BROOKWOOD PROPERTIES SELF STORAGE **SUBDIVISION**

APPLICATION NUMBER 7 DATE August 20, 2020

DETAIL SITE PLAN

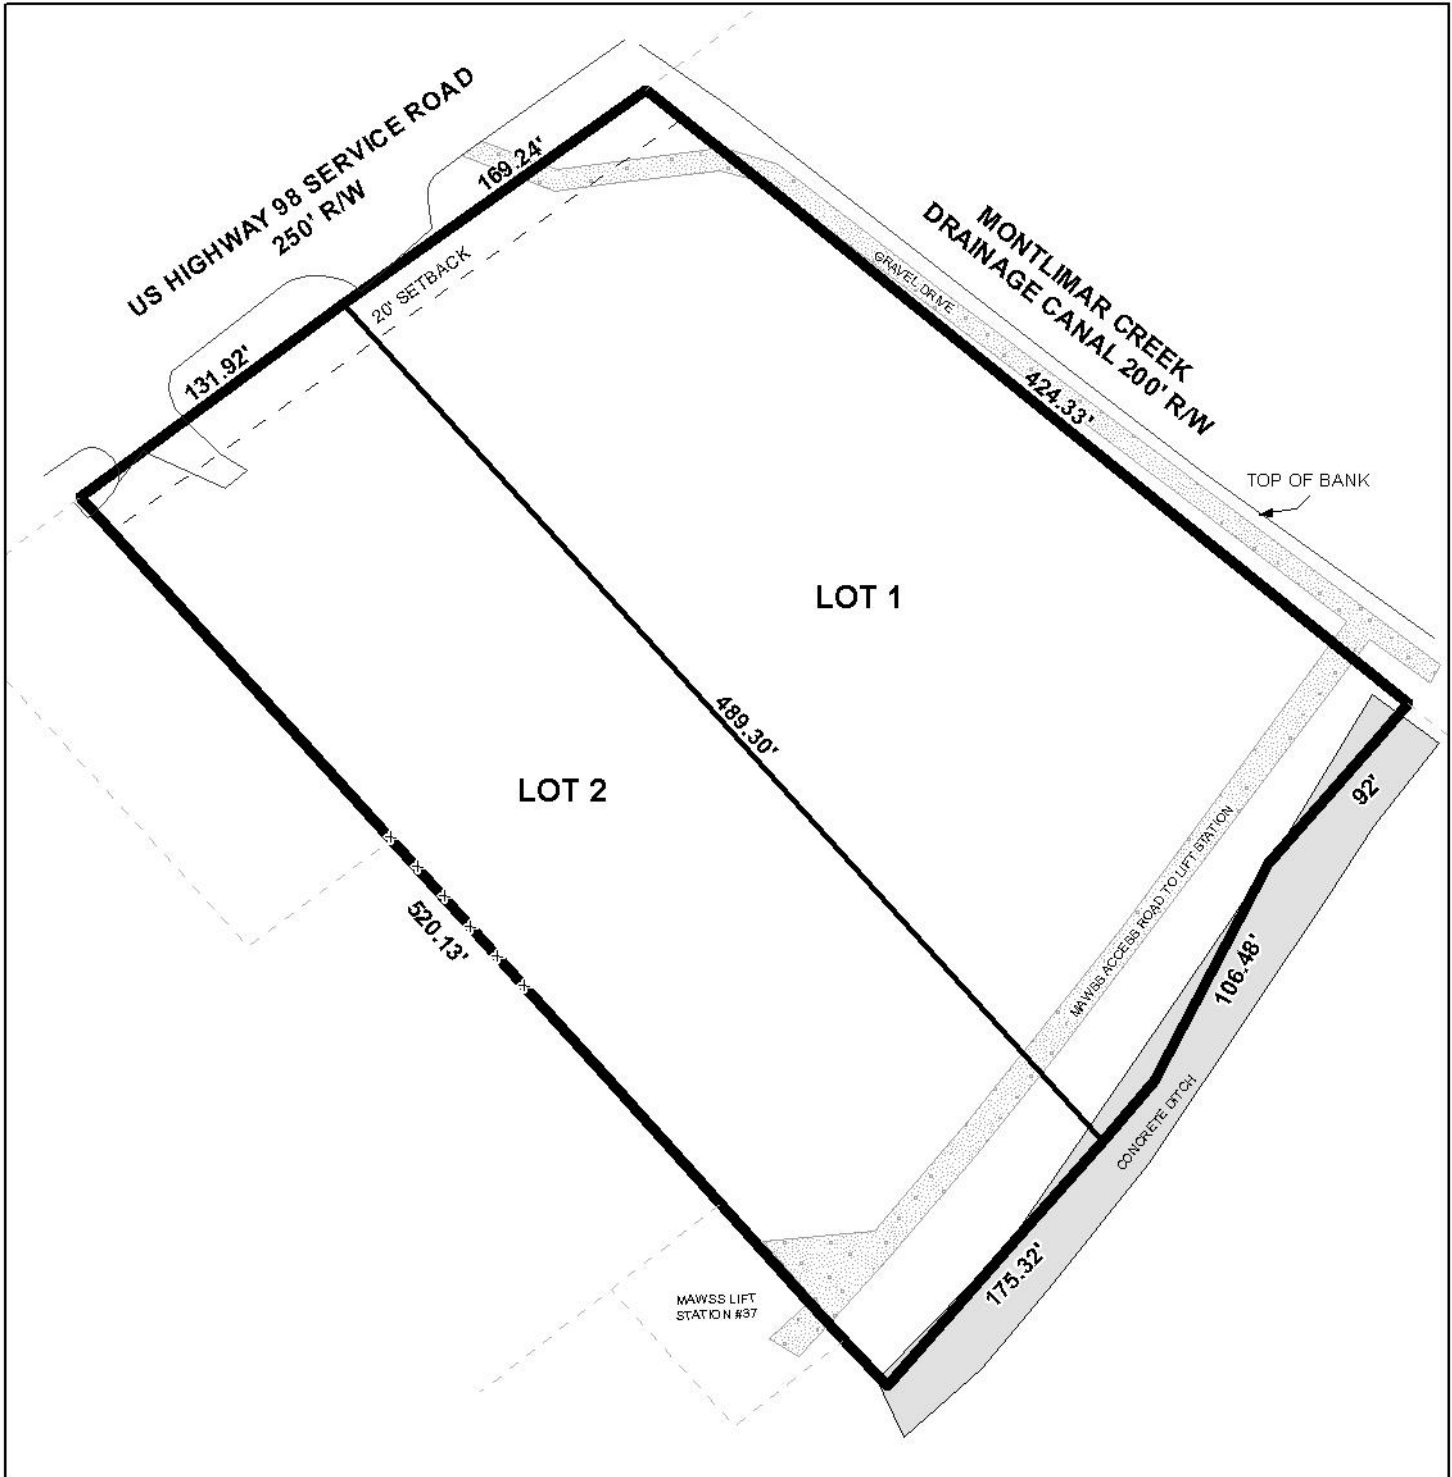
- B. Show and label each and every Right-Of-Way and easement. GIS information indicates a drainage easement exists along the south property line for the existing concrete ditch and references a document recorded in RPB 1363 PG78.

- C. Show the monuments set at the interior lot line between LOT 1 and LOT 2.
- D. Revise NOTE #1 – clarify the date of the Flood Insurance Rate Map.
- E. Provide the Surveyor's and Owner's (notarized) signatures.

The preliminary plat indicates a proposed 20' minimum building setback line along Government Boulevard instead of the required 25' setback. Therefore, if the subdivision is approved, it should be subject to the applicant having a Front Yard Setback Variance approved by the Board of Zoning Adjustment prior to the signing of the Final Plat. A waiver of Section V.D.9. of the Subdivision Regulations would be required if the Variance is approved. It should be noted that, if that Variance is approved, the applicant must wait at least 15 days following the Board's approval until the Final Plat can be signed. Should the Setback Variance not be approved, the Final Plat should be revised to indicate at least a 25' front minimum building setback line.

The preliminary plat indicates an access road along a portion of the front and rear of the site to the Mobile Area Water and Sewer System (MAWSS) lift station located adjacent to the South side of the site. Although not indicated as an easement, a note should be required on the Final Plat stating that no structures shall be constructed or placed within any easement without permission of the easement holder.

- 1) retention of the right-of-way width of Government Boulevard on the Final Plat;
- 2) subject to the approval of a Front Yard Setback Variance by the Board of Zoning Adjustment for the proposed 20' minimum building setback line along Government Boulevard prior to the signing of the Final Plat, or the revision of the Final Plat to indicate at least a 25' front minimum building setback line;

- 4) placement of a note on the Final Plat stating that no structures shall be constructed or placed within any easement without permission of the easement holder;
